Revisions Submitted February 12, 2016

RE: 267 Great Road
Site Plan Special Permit # 11/06/15-458

SITE PLAN FOR ACTON MANAGEMENT, INC. 267 GREAT ROAD ACTON, MASSACHUSETTS

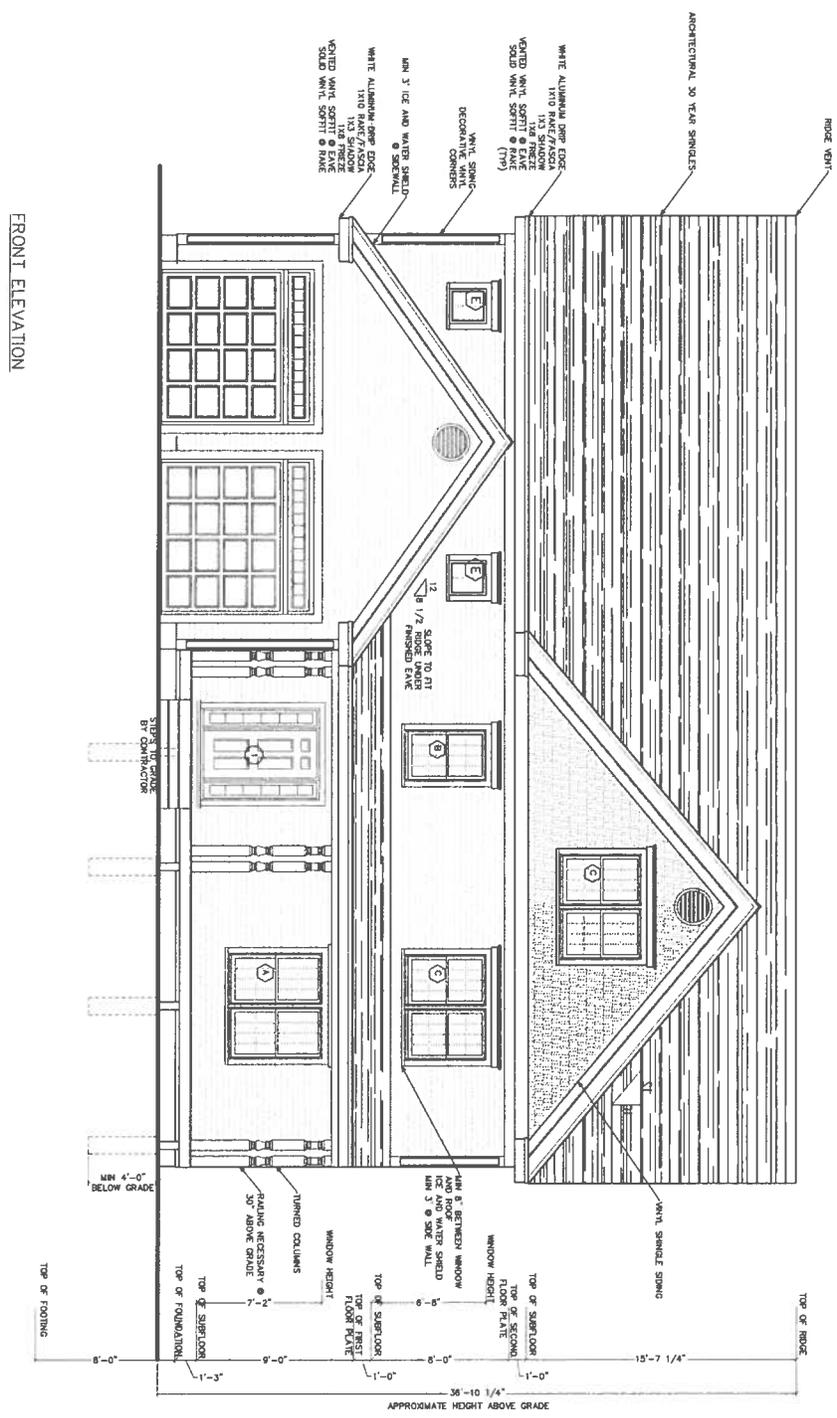
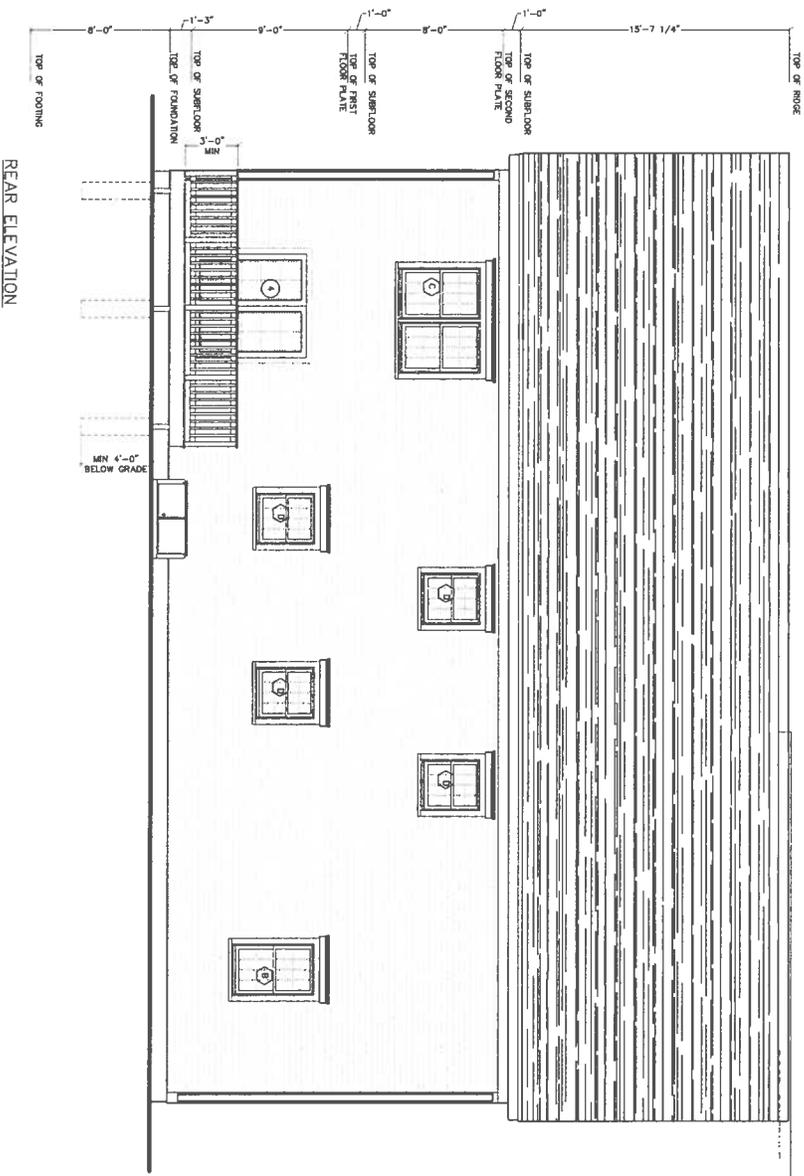
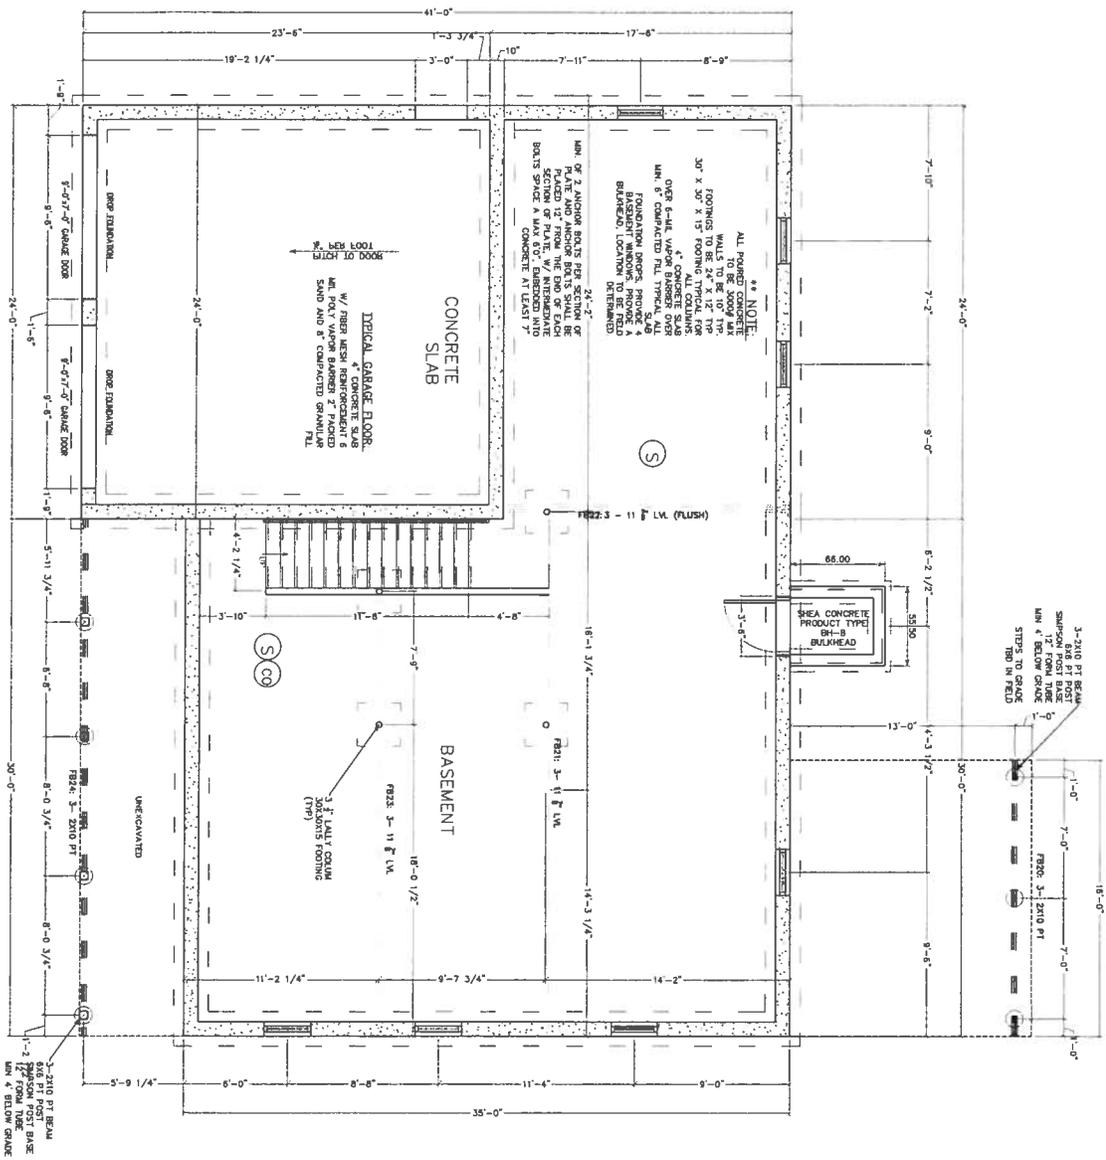
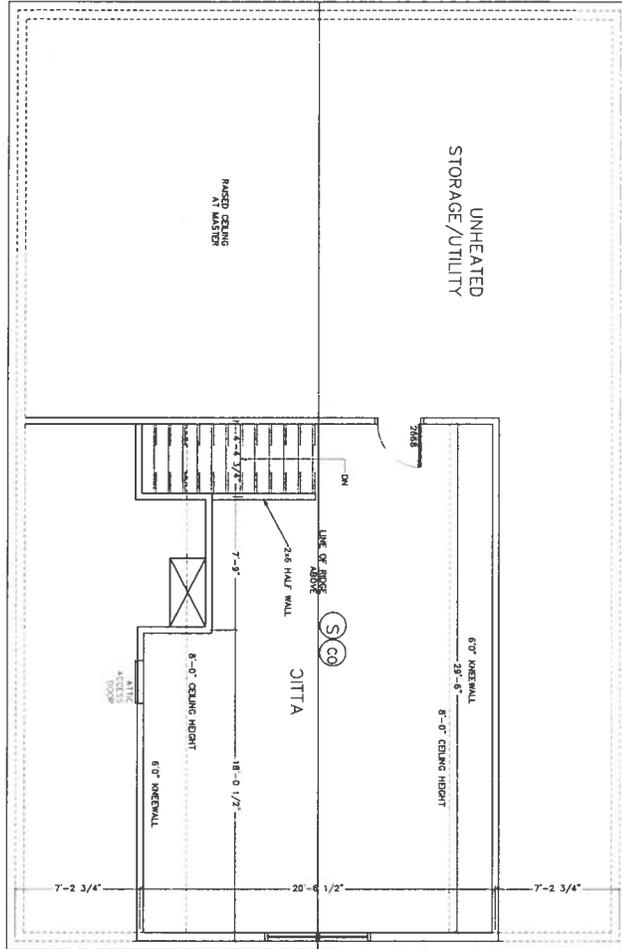
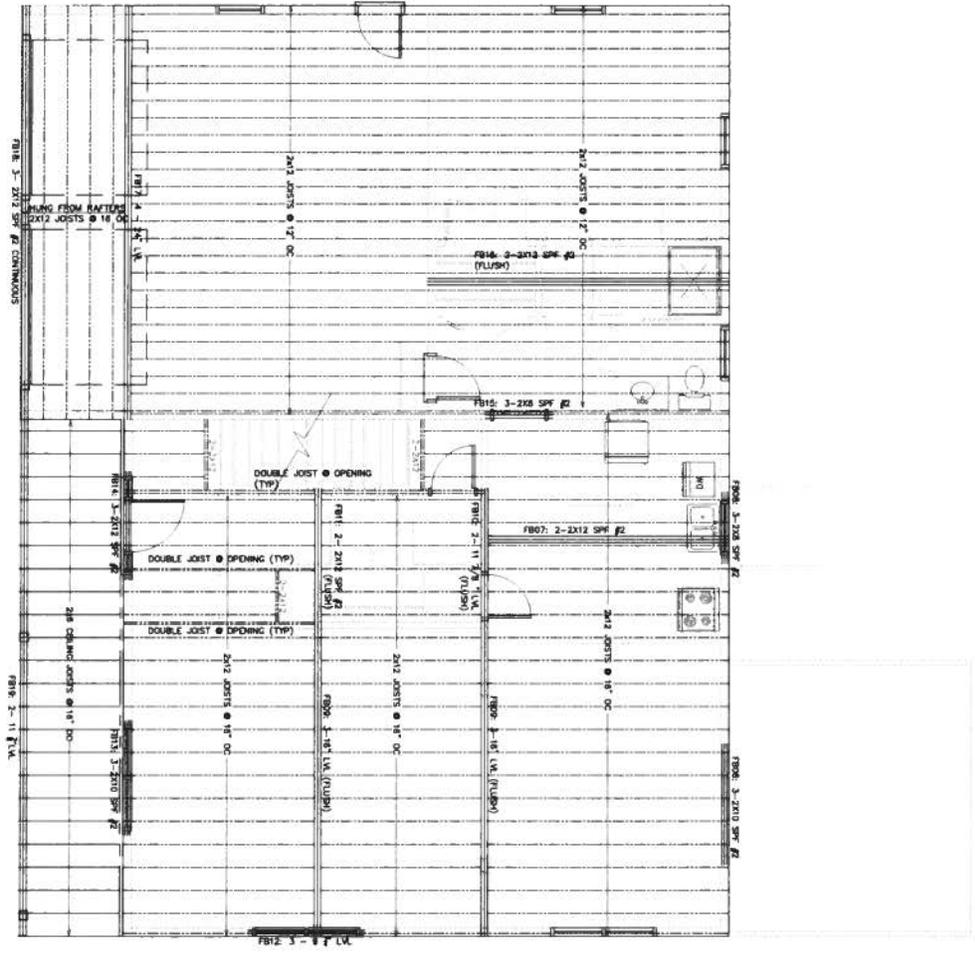
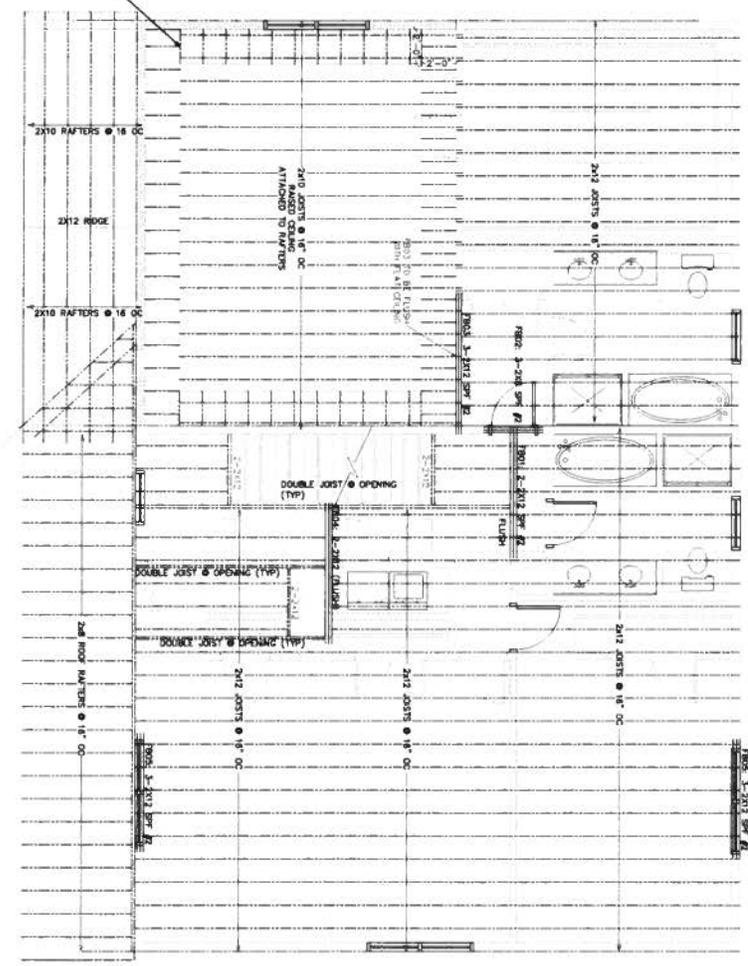
1. No architectural drawing submitted to review.

1. Complete architectural drawings have been provided.
